**ZONING AMENDMENT
& SUBDIVISION STAFF REPORT**

Date: December 1, 2016

Moss Creek Addition to Brookview at Brookside
Subdivision

SITE PLAN

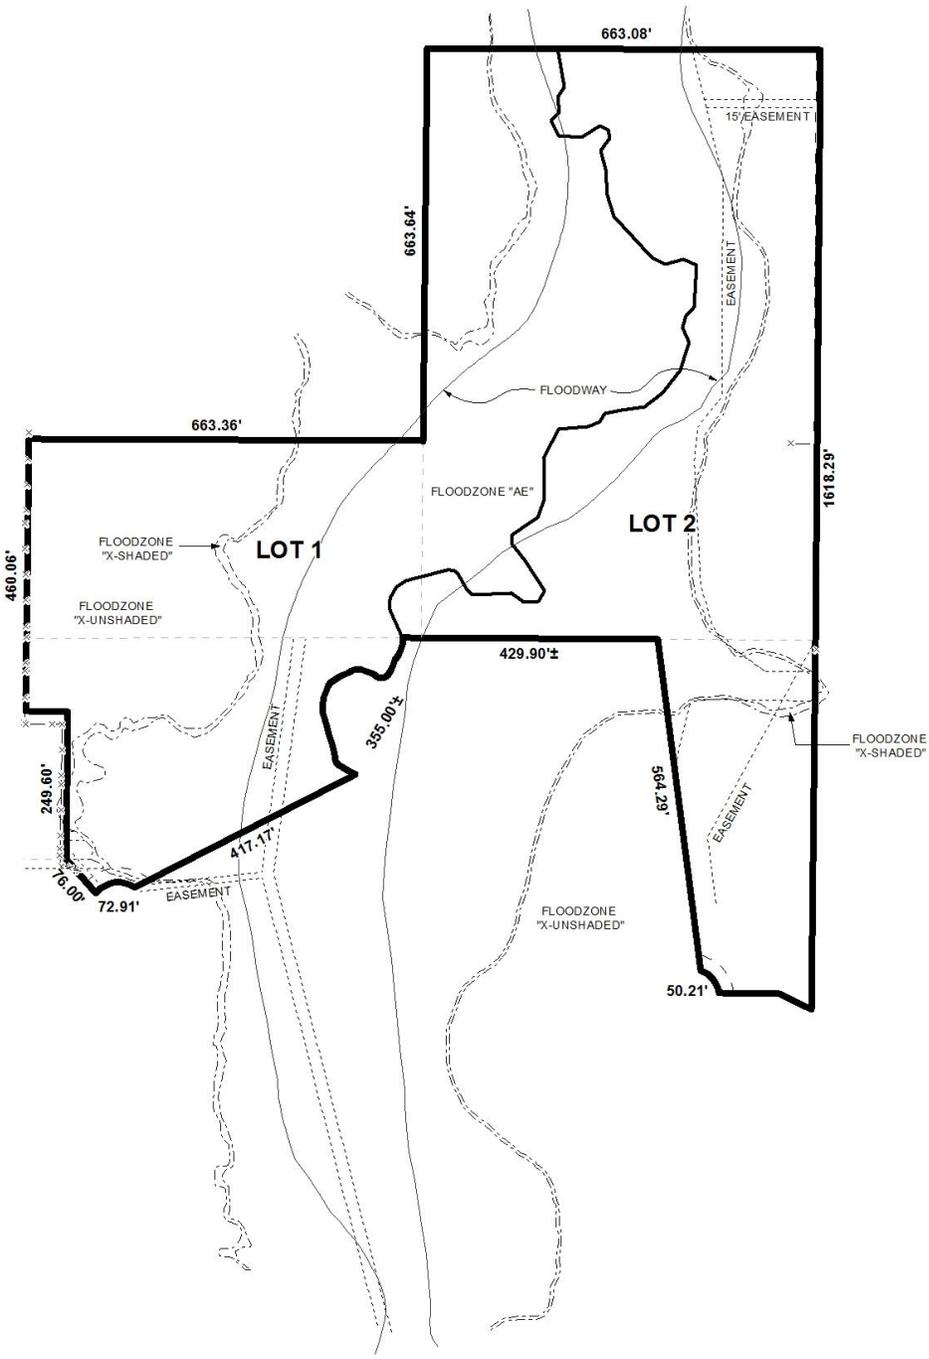
- B. Boundary line between LOT 1 and 2 was not evident. It appears that the creek centerline is a proposed LOT boundary line.
- C. Show and label the existing roads, culverts, structures, and areas of detention.

- D. Show and label the existing lot lines and recording information.
- E. Provide and label the monument set or found at each subdivision corner.
- F. Provide information about the wetlands – date of flagging, US Army Corps of Engineers delineation information, extent and limits of wetlands.

- G. Show and label the MFFE (Minimum Finished Floor Elevation) on each lot that contains an AE, V, or X (shaded) flood zone designation. Consult with the Engineering Department for required MFFE.

- H. Show and label each and every drainage easement.
- I. Add a note to the FINAL SUBDIVISION PLAT stating that a Land Disturbance permit will be required for any land disturbing activity in accordance with Mobile City Code, Chapter 17, Storm Water Management and Flood Control; the City of Mobile, Alabama Flood Plain Management Plan (1984); and, the Rules For Erosion and Sedimentation Control and Storm Water Runoff Control.

Multiple easements are illustrated on the preliminary plat, including: a 15' drainage easement in the north of proposed Lot 1; an indeterminate drainage easement toward the center of proposed Lot 1; an Alabama Power easement in the south of proposed Lot 1; an indeterminate drainage easement in the north of proposed Lot 2; two 15' drainage easements in the southeast of proposed Lot 2; and, a 20' water and sewer easement in the southeast of proposed Lot 2. As such, a note should be required on the Final Plat stating no structures will be constructed in any easement.

It should be noted that there is some confusion with respect to the identification labels of the proposed lots, as well as with respect to proposed lot lines: both Lot 1 and Lot 2 are illustrated as being the same lot; and, various lot lines are emboldened on the preliminary plat, thus rendering the boundaries of each lot ambiguous. Also, the vicinity map on the preliminary plat incorrectly illustrates lots not included in the proposed subdivision. As such, if approved, the Final Plat should be revised to clarify the aforementioned ambiguities, as well as illustrate an appropriate vicinity map.

- 5) placement of a note on the Final Plat stating no structures will be constructed in any easement;
- 6) revision of the plat to correctly identify each lot and clarify lot lines;

- 7) revision of the plat to show a correct vicinity map;
- 8) compliance with Engineering comments: (*FINAL PLAT COMMENTS (should be addressed prior to submitting the FINAL PLAT for acceptance and signature by the City Engineer): A) Provide all of the required information on the FINAL SUBDIVISION PLAT (i.e. signature blocks, signatures, certification statements, written legal description, required notes, legend, scale, bearings and distances) that is required by the current Alabama State Board of Licensure for Professional Engineers and Land Surveyors. B) Boundary line between LOT 1 and 2 was not evident. It appears that the creek centerline is a proposed LOT boundary line. C) Show and label the existing roads, culverts, structures, and areas of detention. D) Show and label the existing lot lines and recording information. E) Provide and label the monument set or found at each subdivision corner. F) Provide information about the wetlands – date of flagging, US Army Corps of Engineers delineation information, extent and limits of wetlands. G) Show and label the MFFE (Minimum Finished Floor Elevation) on each lot that contains an AE, V, or X (shaded) flood zone designation. Consult with the Engineering Department for required MFFE. H) Show and label each and every drainage easement. I) Add a note to the FINAL SUBDIVISION PLAT stating that a Land Disturbance permit will be*
